ADDENDUM NO. 2

TSA OFFICE BUILD-OUT

SYRACUSE HANCOCK INTERNATIONAL AIRPORT
SYRACUSE REGIONAL AIRPORT AUTHORITY
SYRACUSE, NEW YORK

IFB REFERENCE #2021-07

E-102

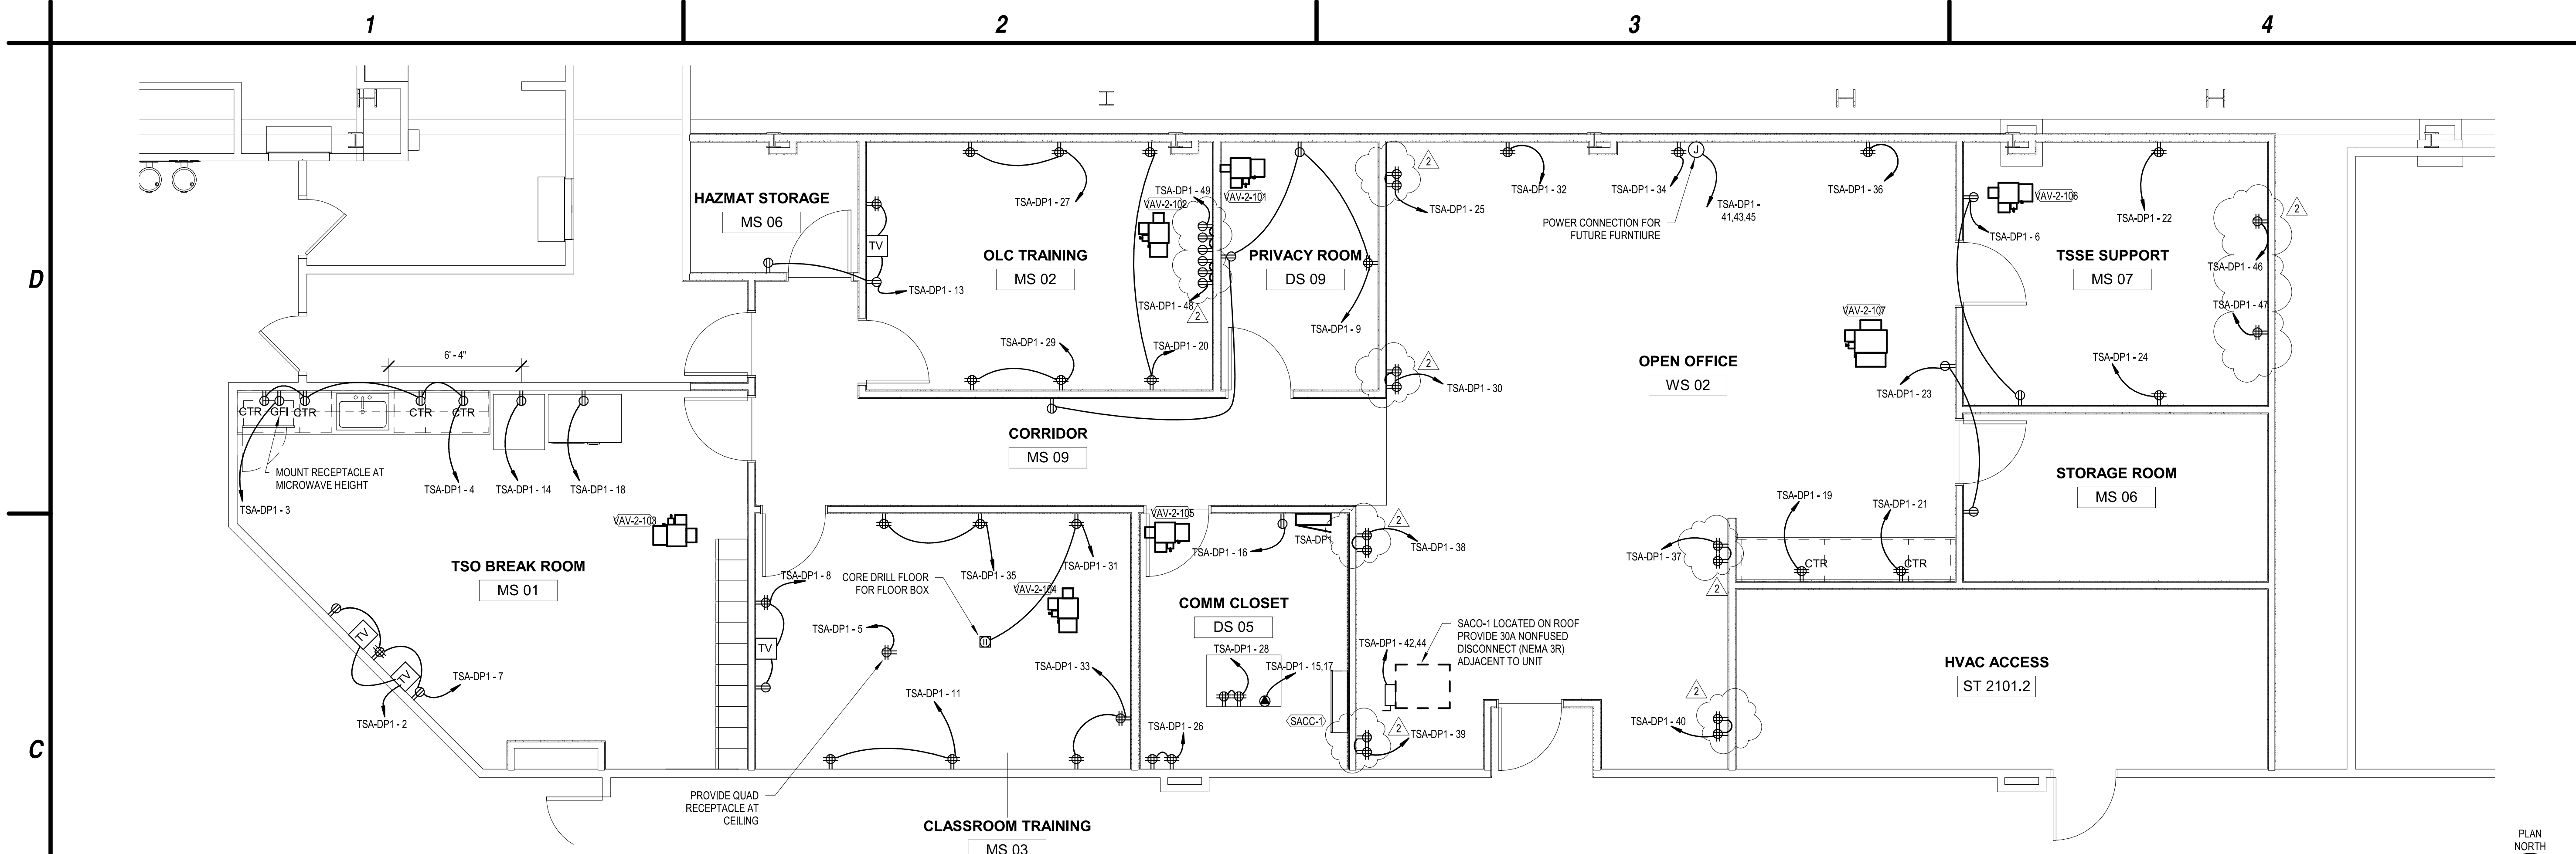
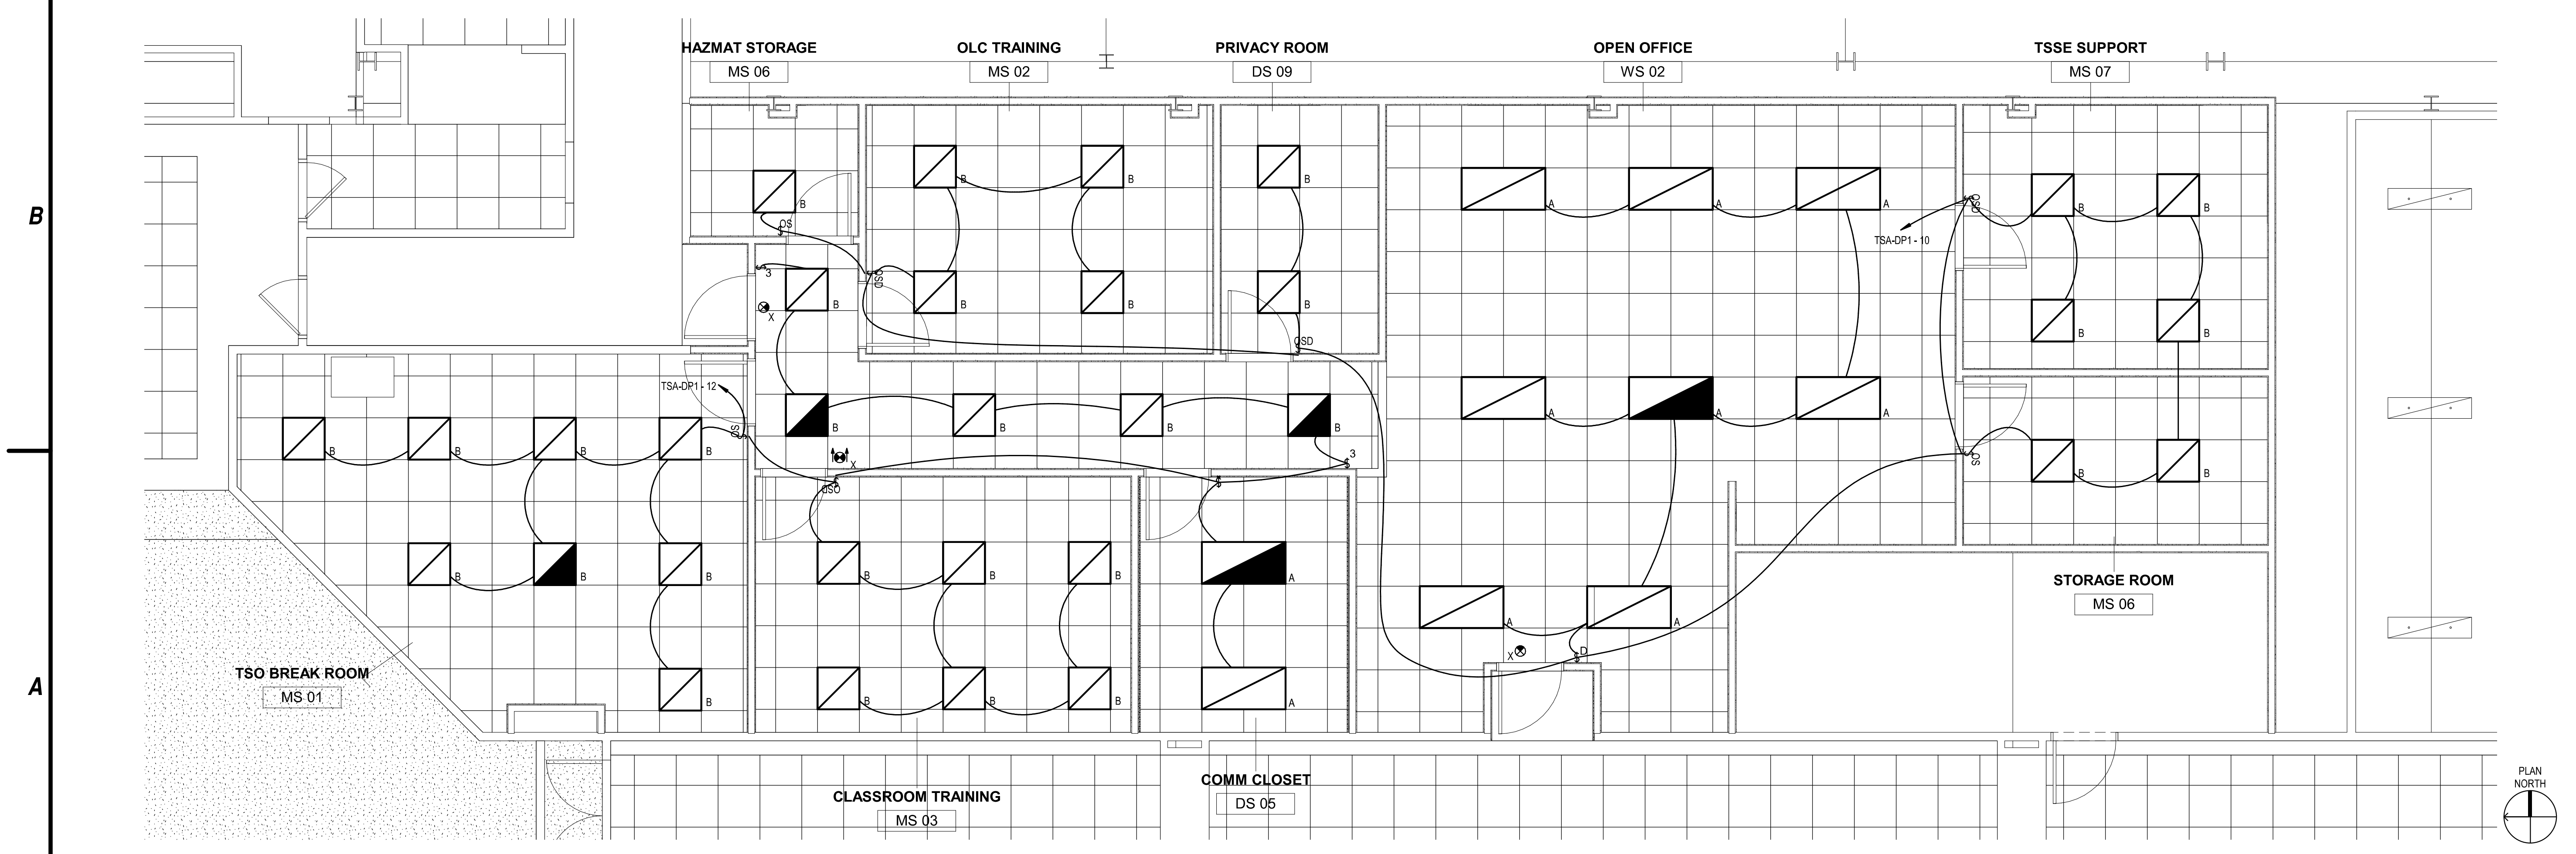
- ELECTRICAL NOTES:**
1. CIRCUIT VAV UNITS TO TSA-DP1-1.
 2. SACC-1 POWERED FROM SACC-1.
 3. LINE-VOLTAGE WIRING AND CONDUIT BY ELECTRICAL. CONTROL-VOLTAGE WIRING AND CONDUIT BY MECHANICAL CONTRACTOR.
